80960HA/HD/HT SPECIFICATION UPDATE

Release Date: January, 1997

Order Number: 272830-002

The 80960HA/HD/HT may contain design defects or errors known as errata. Characterized errata that may cause the 80960HA/HD/HT's behavior to deviate from published specifications are documented in this specification update.

Figure 6-4. icctl *src1* and *src/dst* Formats

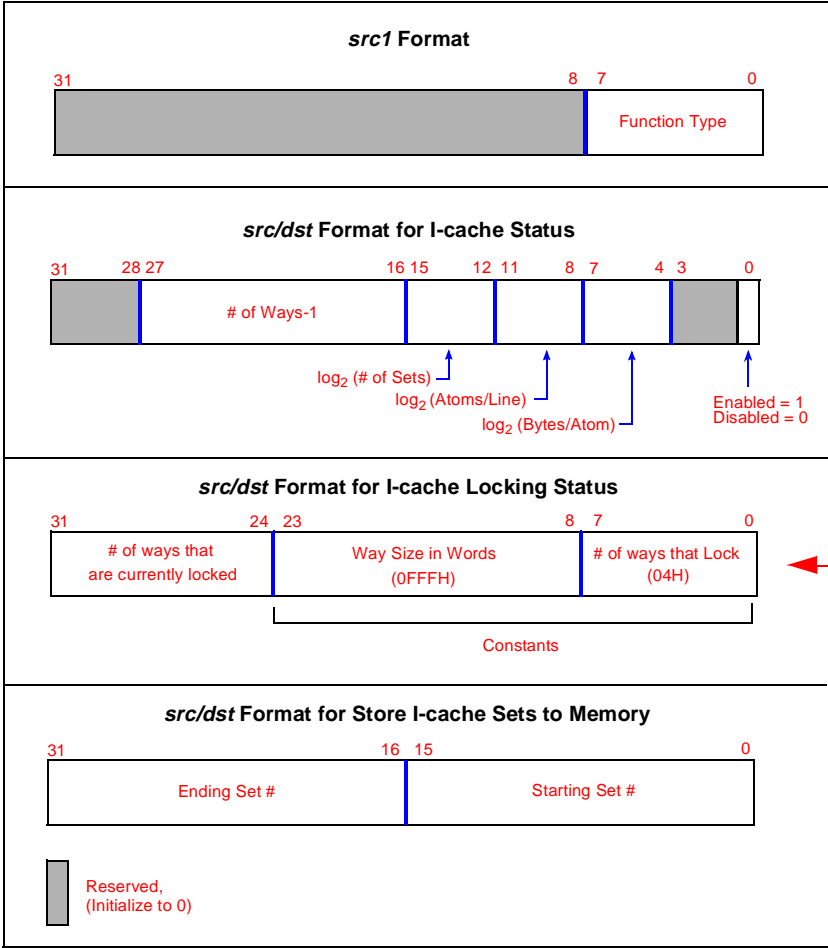
7. Page 6-61, Figure 6-4

ISSUE: Under "Src/Dst Format for L_cache Locking Status", constant fixed values for bits 0 - 23 have been added. The corrected page is appended to this document.

Page 6-61, Figure 6-4

In Figure 6-4 under "Src/Dst Format for I-cache Locking Status" constant fixed values for bits 0 - 23 are shown.

Figure 6-5. Store Instruction Cache to Memory Output Format

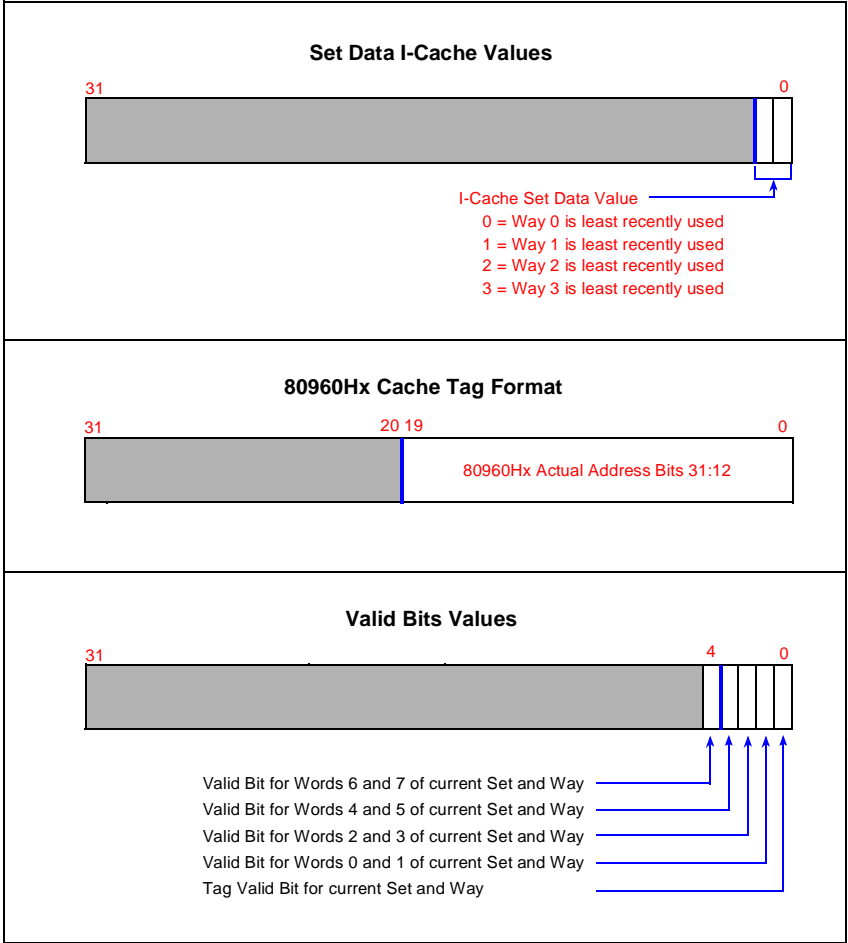
9. Page 6-63, Figure 6-5

Page 6-63, Figure 6-5
 Each way in Figure 6-5 should have 8 words, as opposed to the 4 originally shown.

Figure 13-2. Cold Reset Waveform

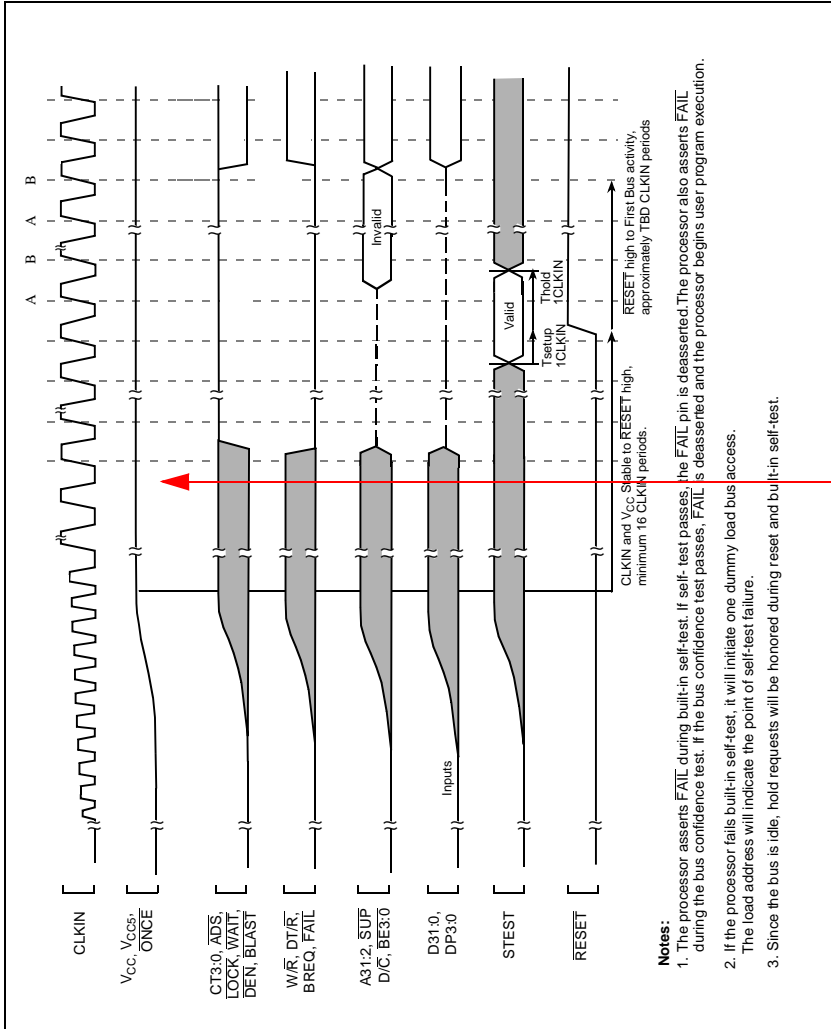
15. Page 13-4, Figure 13-2

Page 13-04, Figure 13-2
 The text that appeared near the top center of the diagram:
 V_{CC} and CLKIN Stable to Outputs Valid, maximum 32 CLKIN Periods.
 has been deleted.

Figure 13-9. VCCPLL Lowpass Filter

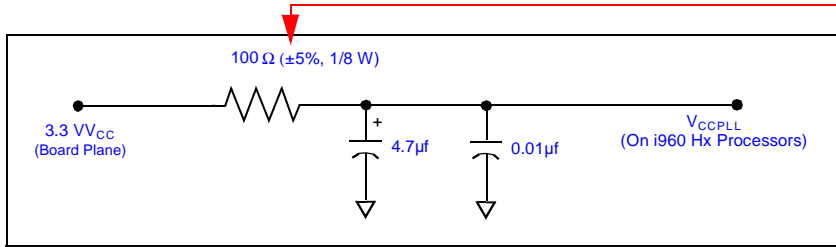
19. Page 13-37, Figure 13-9

ISSUE: The text near the top of the figure read: 100 Ohms.

Page 13-37, Figure 13-9
 The text near at the top of the figure read:
 100Ω
 The corrected text reads:
 100Ω (±5%, 1/8 W)

Figure 15-5. 32-Bit-Wide Data Bus Bursts

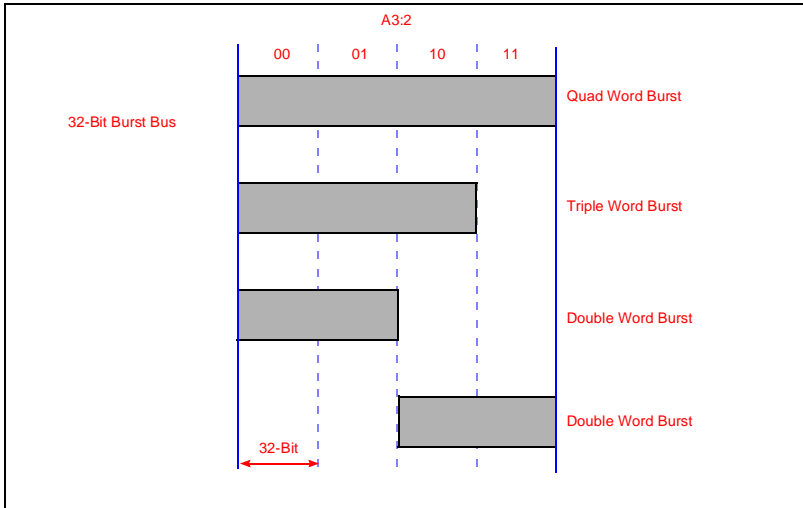
FROM/TO REFERENCE: Section 15.3.2 Burst Accesses, page 15-14. Insert the description and impact text above (sans the “Description” and “Impact” titles) to the bottom of the page, before Figure 15-5 on the following page.

Page 15-15, Figure 15-5
